## **E702 – Proposed District Centre Roundabout, Derby**

### **Stage 1 Road Safety Audit Response**

**Stage 1 Road Safety Audit**

**Chellaston Lane Roundabout**

#### 4.3.1. Problem

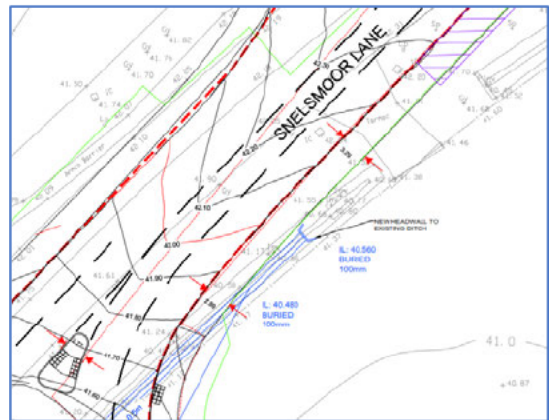
The northbound approach is on a right hand horizontal curve. The offset roundabout construction may lead to poor forward visibility to the junction and 'see through' issues for northbound drivers, which may lead to late braking loss of control or overshoot type collisions.

The forward visibility along Chellaston Lane for southbound users may be reduced by the horizontal curve and landscaping alongside the carriageway. This may also contribute to late braking or loss of control type collisions.

It is recommended that adequate stopping sight distance is provided along this section of Chellaston Lane, consistent with likely vehicle speeds. Measures should be introduced to minimise the likelihood of 'see through' issues along Chellaston Lane; measures may include strategic landscaping on the kerbed build-out area.

| Items Raised by Stage 1 Road Safety Audit |                                                                                                                                                                                                                                                                                                                                                                                                                                                                                                                                                                                                                                                                                                    |                                                                                                                                                                                                                                                                                                                                                                                                                                                                  |                                                                                                                                                                                                                                                                                                                                                                                                                                                                                                                                                                                                                                                          |                            |
|-------------------------------------------|----------------------------------------------------------------------------------------------------------------------------------------------------------------------------------------------------------------------------------------------------------------------------------------------------------------------------------------------------------------------------------------------------------------------------------------------------------------------------------------------------------------------------------------------------------------------------------------------------------------------------------------------------------------------------------------------------|------------------------------------------------------------------------------------------------------------------------------------------------------------------------------------------------------------------------------------------------------------------------------------------------------------------------------------------------------------------------------------------------------------------------------------------------------------------|----------------------------------------------------------------------------------------------------------------------------------------------------------------------------------------------------------------------------------------------------------------------------------------------------------------------------------------------------------------------------------------------------------------------------------------------------------------------------------------------------------------------------------------------------------------------------------------------------------------------------------------------------------|----------------------------|
| 4.3.1                                     | <p><b>Location:</b> On Chellaston Lane</p> <p><b>Summary:</b> Reduced forward visibility may lead to late braking loss of control or overshoot type collisions</p> <p>The northbound approach is on a right hand horizontal curve. The offset roundabout construction may lead to poor forward visibility to the junction and 'see through' issues for northbound drivers, which may lead to late braking loss of control or overshoot type collisions.</p> <p>The forward visibility along Chellaston Lane for southbound users may be reduced by the horizontal curve and landscaping alongside the carriageway. This may also contribute to late braking or loss of control type collisions</p> | <p>It is recommended that adequate stopping sight distance is provided along this section of Chellaston Lane, consistent with likely vehicle speeds. Measures should be introduced to minimise the likely hood of 'see through' issues along Chellaston Lane; measures may include strategic landscaping on the kerbed build out area.</p>                                                                                                                       | <p>Although it is noted that Chellaston Lane is not a trunk road, forward visibility on the southern approach to the junction has been provided in accordance with Figure 3.39 of DMRB CD116 Revision 2. Stopping sight distance can be accommodated up to 120m (40mph design speed) however it is considered that when the roundabout is implemented vehicles will be travelling slower given the proximity of the existing 30mph/40mph gateway on this approach. Therefore 90m is considered to be more appropriate.</p> <p>In addition to the above appropriate signage will be provided at the junction which will be agreed at detailed design.</p> |                            |

## APPENDIX 2: Drawing Showing Problem Locations

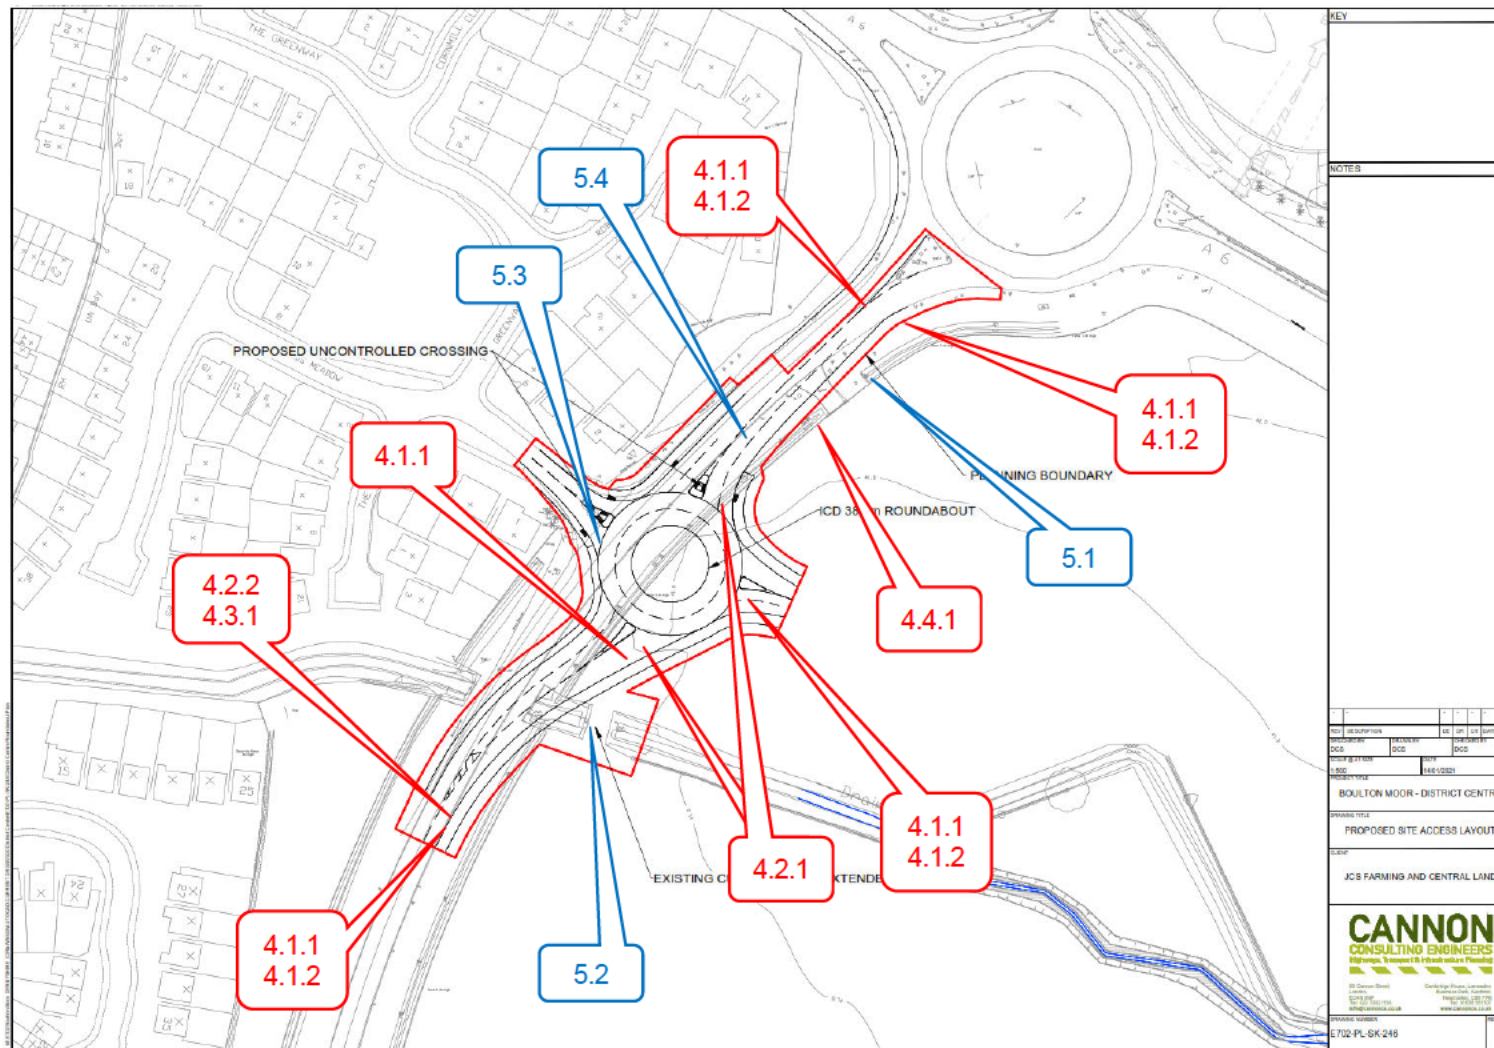
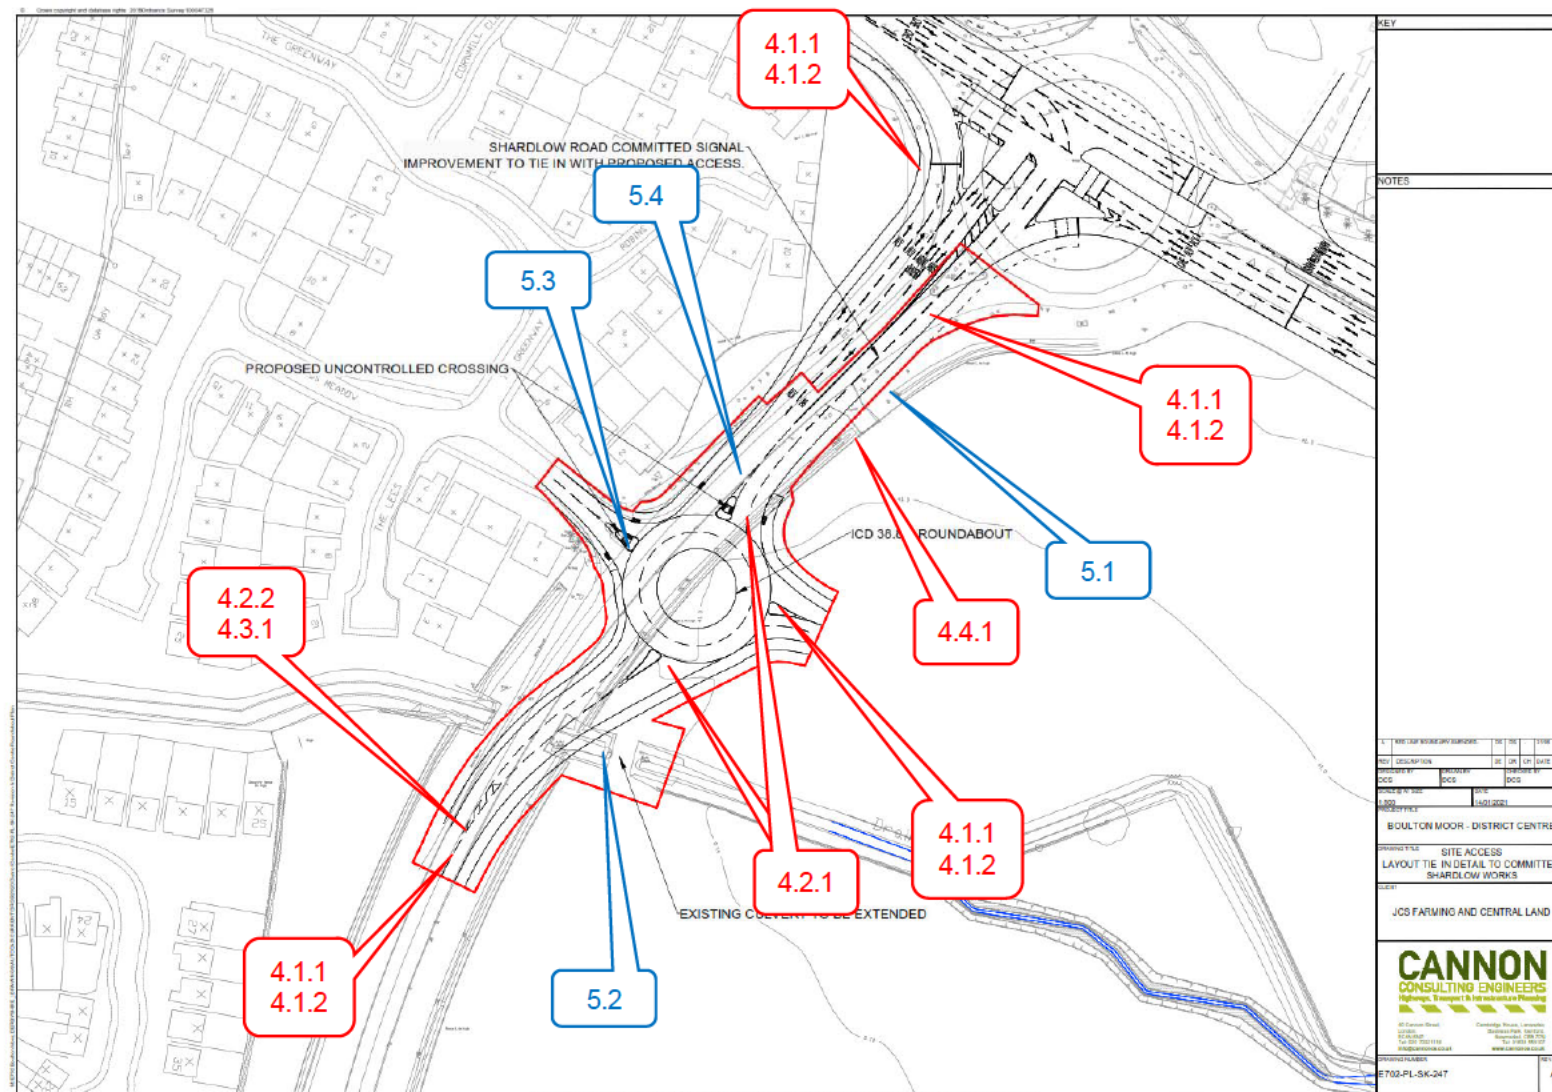
Problem numbers shown on the attached drawing refer to Problem numbers within the report.
